PROJECT STATUS **RIBA Stage 5**

PROJECT **Our Town Hall**

DRAWING TITLE **Princess Street extension
link corridor detail**

OTH-PUR-TH-RF-DWG-A-7021 05

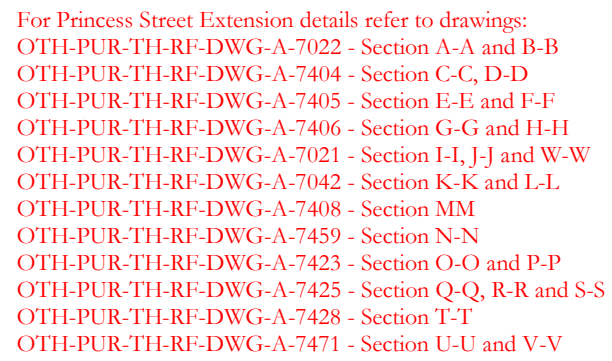
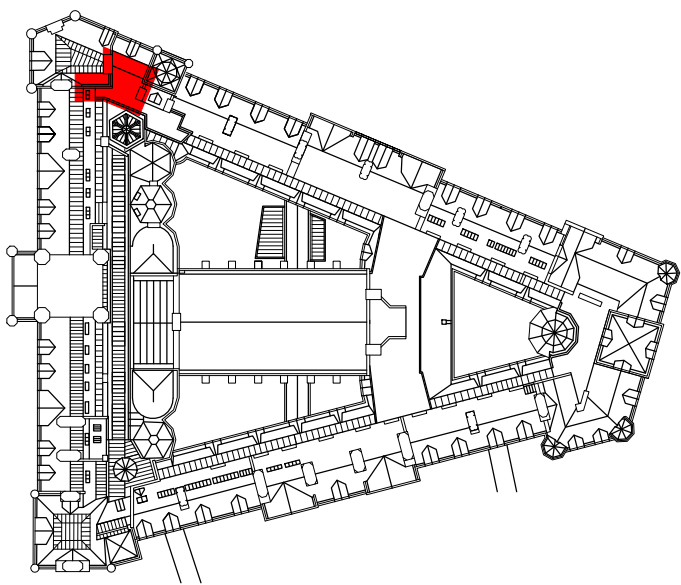
Revision 05: Detail section W-W added to drawing and title of drawing amended

Revision 04: Notes amended with fixing details of timber to steel. Sheathing changed from cement board to Glasroc X

Revision 03: Timber fixing note added

Revision 02: Ceiling detail updated to correspond with drawing 5683. Internal wall lining amended to show 2 No. layers of 15mm Gyproc Fireline board and Gyproframe channels

Revision 01: Arrangement of roof joists and firrings amended.
Notes added for plasterboard lining and cement board sarking.
Status changed to S4 Construction
